MEMORANDUM

Date: ~~April 25, 2024~~ ~~November 19, 2024~~ March 14, 2025
To: Aditya Jatar, BOE
CC: Kaylie Coleman, Bryan Golden,
Transportation and Public Works Department
Reference: **200 E Riverside PUD Traffic Impact Analysis** (C814-2023-0057) – 200 E Riverside Dr, Austin, Final Memo

Figure 2. Improvement Extent

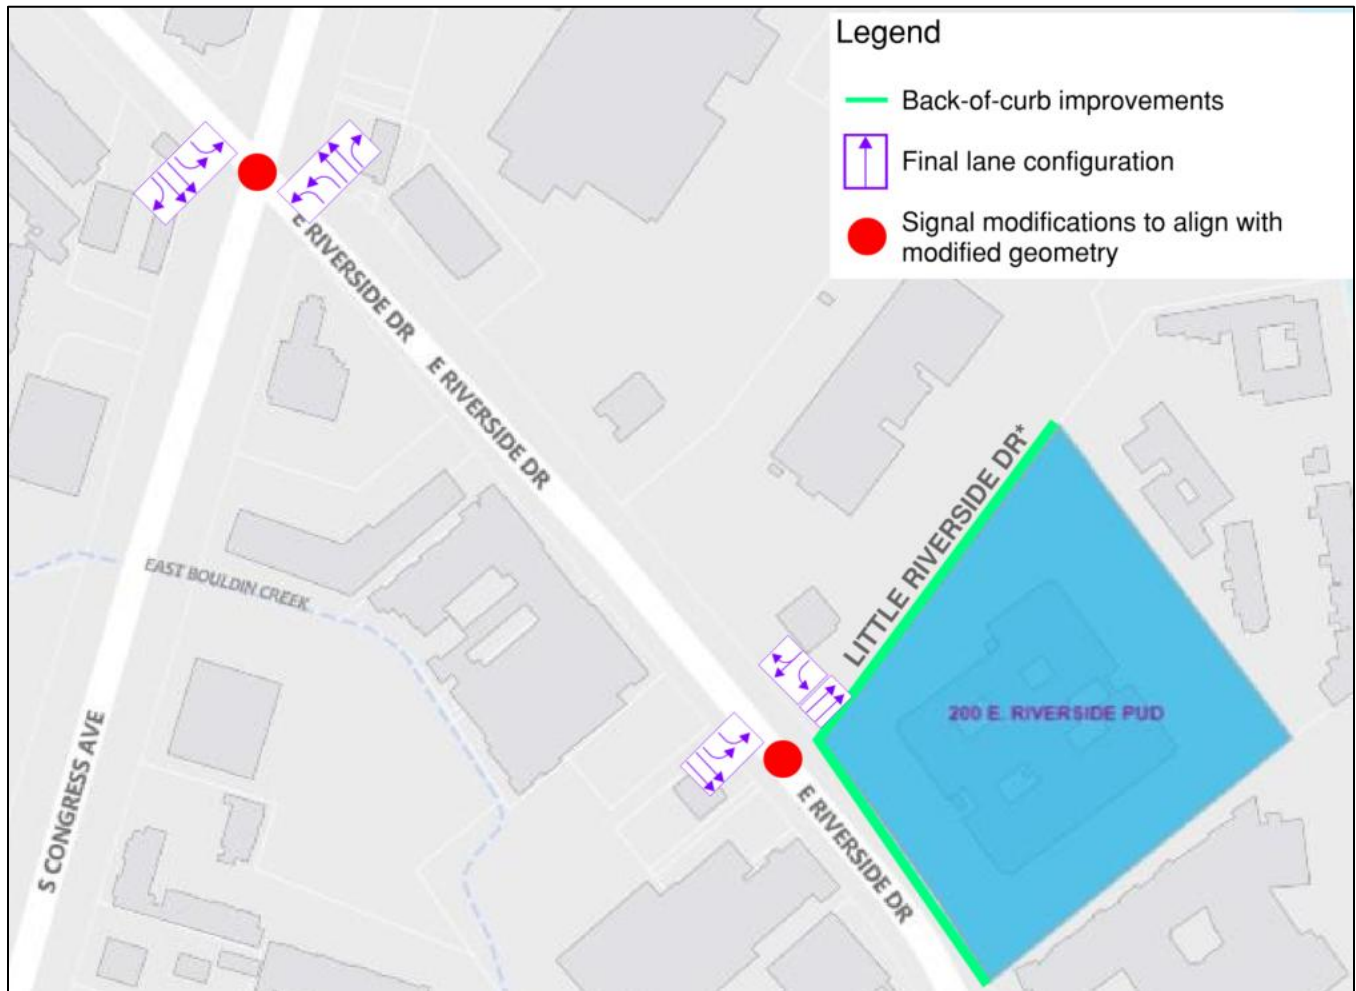
<p><i>Table 2. Improvements Identified in the TIA</i> (This will be reevaluated at the time of the site plan when more information about the site and Project Connect is available.)</p>	
Name	Improvement
E Riverside Dr & Little Riverside Dr* (See Figure 2 for the improvement extent)	Restripe existing pavement to 1L, 1 TR along SB Little Riverside Dr* approach to accommodate SB LTL on Little Riverside Dr*
	Provide 1 additional LTL to create dual left turn lanes along EB approach
	Widen NB approach with merge taper along Little Riverside Dr* to provide additional receiving lane for EB to NB dual left turns
	Signal re-timing, lane assignment sign, signal head modification as needed to align with modified geometry
E Riverside Dr & S Congress Ave (See Figure 2 for the improvement extent)	Install 1 additional LTL to create dual left turn lanes along EB E Riverside Dr approach
	Install 1 additional LTL to create dual left turn lanes along WB E Riverside Dr approach

Install 1 RTL along WB E Riverside Dr approach
	Signal re-timing, lane assignment sign, signal head modification as needed to align with modified geometry
Back-of-curb Improvements (See Figure 2 for the improvement extent)	Design and construct back-of-curb improvements with the coordination of TPW along site frontages on Little Riverside Dr* & E Riverside Dr
